Access Compliance Report

Public Rights-of-Way

(Curb Ramps)

Intersection ID: N/A	Main Street: SOUTHGROVE_ST	Cross Street: WAVERLY_CENTER_DR	Location: NW
ADA ID: 6AC7882DE94B	Ramp Type: Perp	Initial Pass/Fail: Fail	Overall Compliance: No
Severity Score: 8.75			
Codes/Mitigation Info/Possible Solution		Field Measurements/Component Compliance

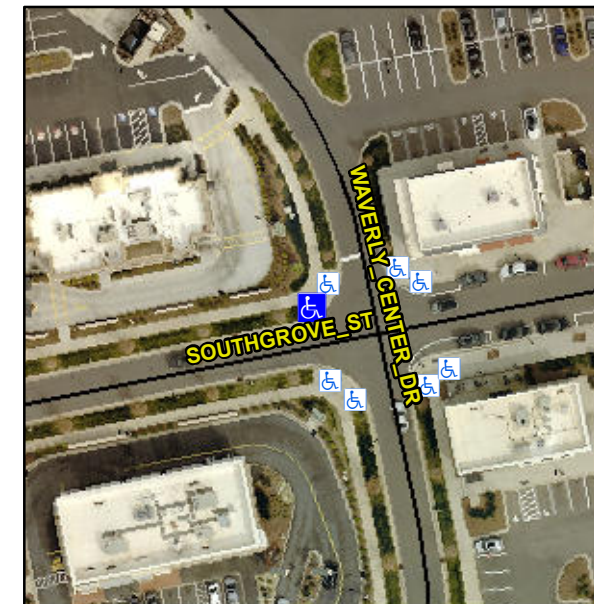
R304.5.1

Compliance	Description	Data	Compliance	Description	Data
N/A	Ramp Length (in)	95.0	Yes	Ramp Slope (%)	6.7
No	Ramp Width (in)	45.5	Yes	Ramp XSlope (%)	1.9
N/A	Flare Type LT	N/A	N/A	Flare Type RT	N/A
N/A	Flare Slope LT (%)	N/A	N/A	Flare Slope RT (%)	N/A
N/A	Flare Traversable LT?	N/A	N/A	Flare Traversable RT?	N/A
N/A	Landing Length (in)	N/A	N/A	DWS Provided?	N/A
N/A	Landing Width (in)	N/A	N/A	DWS Contrast?	N/A
N/A	Landing Slope (%)	N/A	N/A	DWS Length (in)	N/A
N/A	Landing X Slope (%)	N/A	N/A	DWS Full Width?	N/A
N/A	Landing Curb? (Y/N)	N/A	N/A	DWS Offset (in)	N/A
N/A	Shared Landing?	N/A			
N/A	Gutter Ponding?	N/A	N/A	Gutter Slope (%)	N/A
N/A	Gutter Lip Ht (in)	N/A	N/A	Gutter X Slope (%)	N/A
N/A	Painted X Walk1?	No	N/A	Painted X Walk2?	N/A
	X Walk 1 Direction	To S		X Walk 2 Direction	N/A
N/A	X Walk 1 Width (in)	N/A	N/A	X Walk 2 Width (in)	N/A
	X Walk 1 Slope (%)	0.1		X Walk 2 Slope (%)	N/A
	X Walk 1 X Slope (%)	0.7		X Walk 2 X Slope (%)	N/A

Remove & Replace Entire Ramp.
